# Provo River Restoration Project

## Final Environmental Impact Statement

**DECEMBER 1997**

**FINAL  
ENVIRONMENTAL IMPACT STATEMENT  
ON THE  
PROVO RIVER RESTORATION PROJECT**

Figure 1-1  
Schematic Cross-Section  
Riverine Habitat Restoration

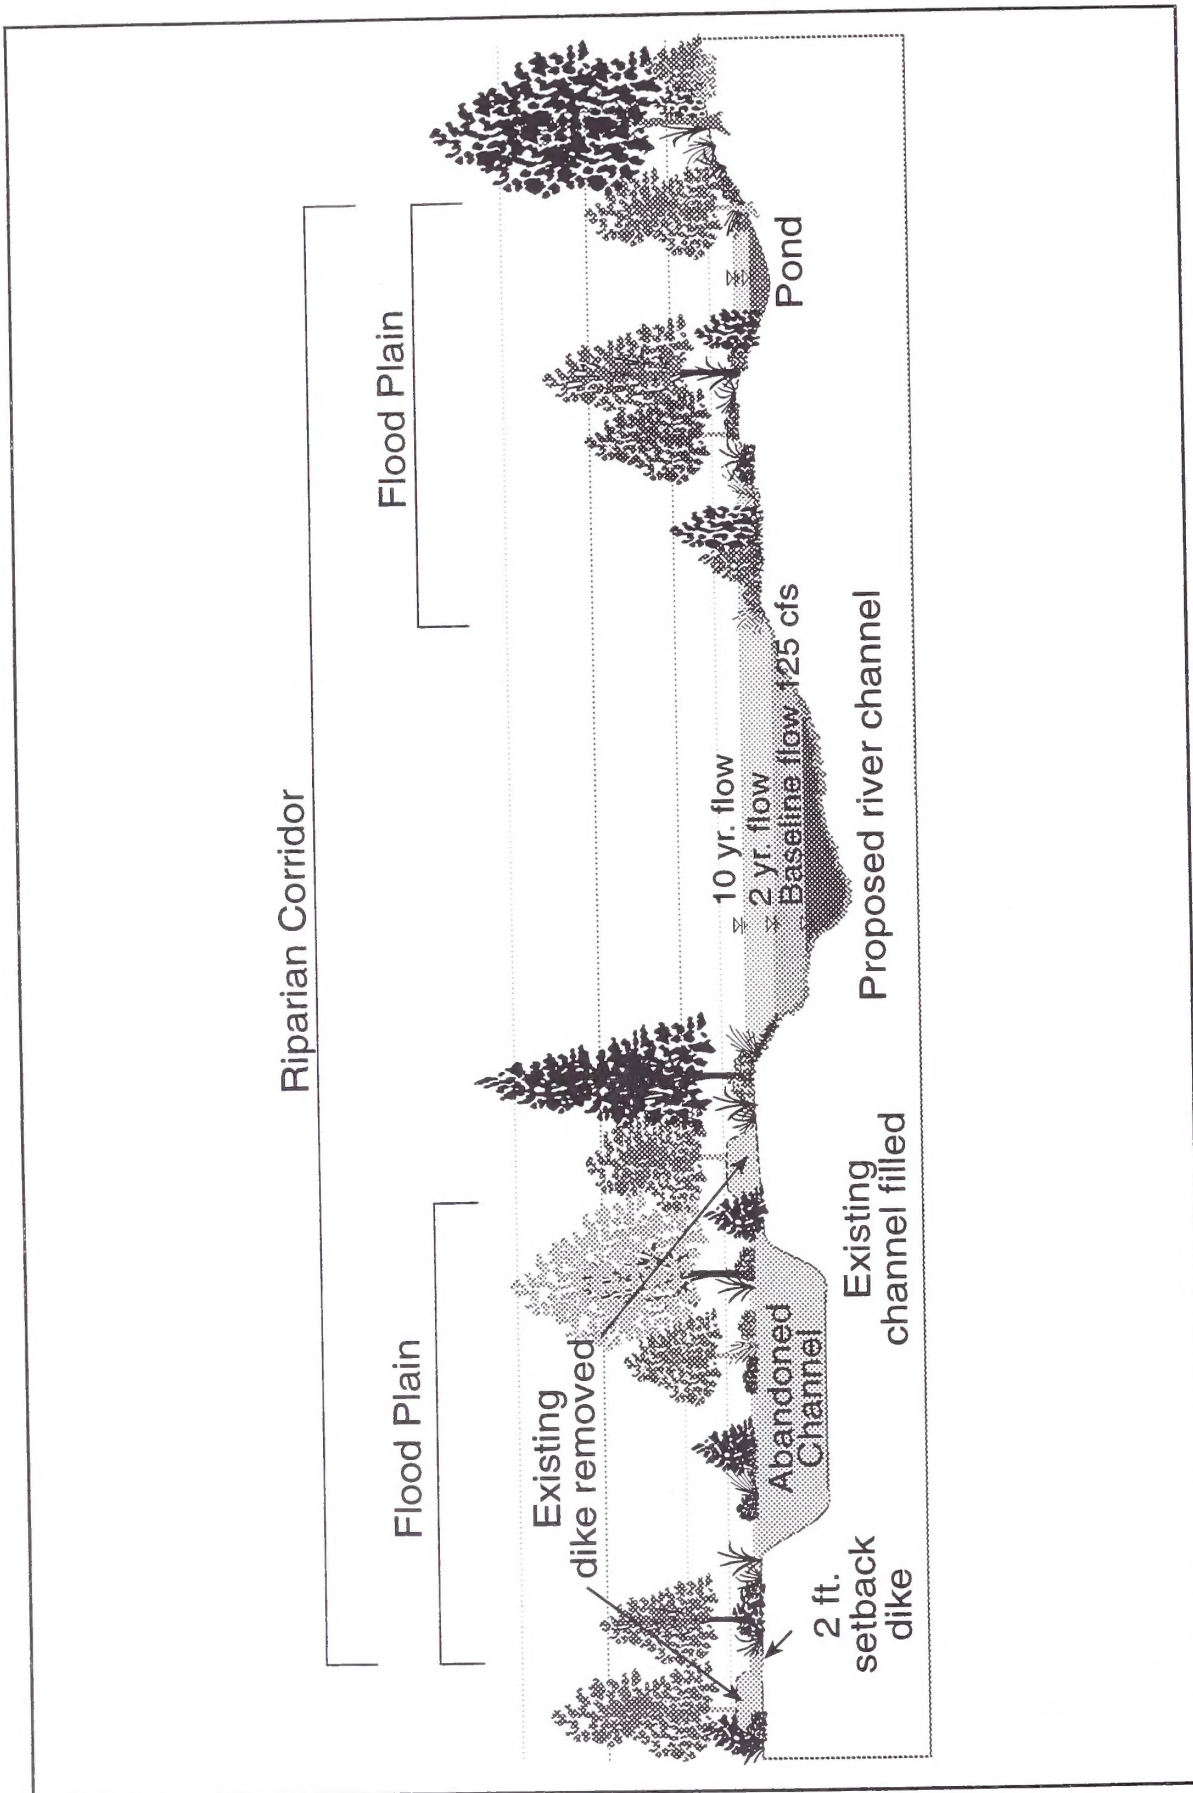
- 20.6 P1-4 **Map 1-1** - Map unfairly shows Rock Ditch but fails to show the Middle or Westside ditches, as if they do not exist. Why?
- 20.7 P1-10 **Figure 1-1** - Cross Section of the proposed Action fails to show the back-filling of the old channel—ostensibly and practically from material removed from the proposed river channel.

20.7 Please refer to note 5 on Figure 1-1 in the Draft EIS, which indicates that the existing channel can be filled or retained for wetland development. Figure 1-1 has been revised in Chapter 1 of the Final EIS to show a more detailed typical cross-section.

Figure 1-10  
 Schematic Drawing of Typical Segment of Provo River Channel  
 Under the Existing Channel Modification Alternative  
 (modified from Rabeni et.al. 1993)

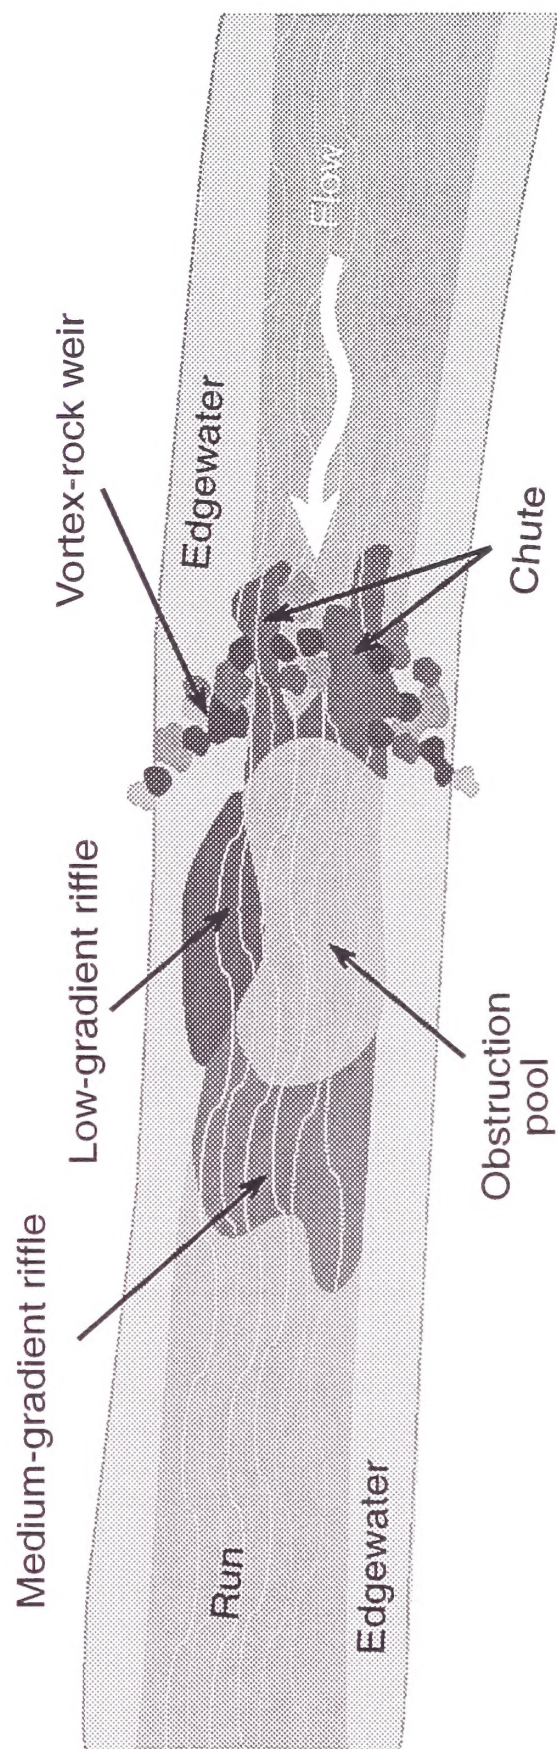
- P1-49 **Figure 1-10** - Why doesn't the Proposed River Channel in the Existing Channel Modification Alternative reflect a more 'natural' cross-section as above?

20.25 The Existing Channel Modification Alternative cross section in Figure 1-10 in the Draft EIS represents a "natural" cross section for a riffle section of a Rosgen B-type (step-pool) channel, which is the predominant channel type in this alternative. The Proposed Action cross section represents a "natural" pool section in a Rosgen C-type (riffle-pool) channel, which is the predominant channel type proposed for the Proposed Action.
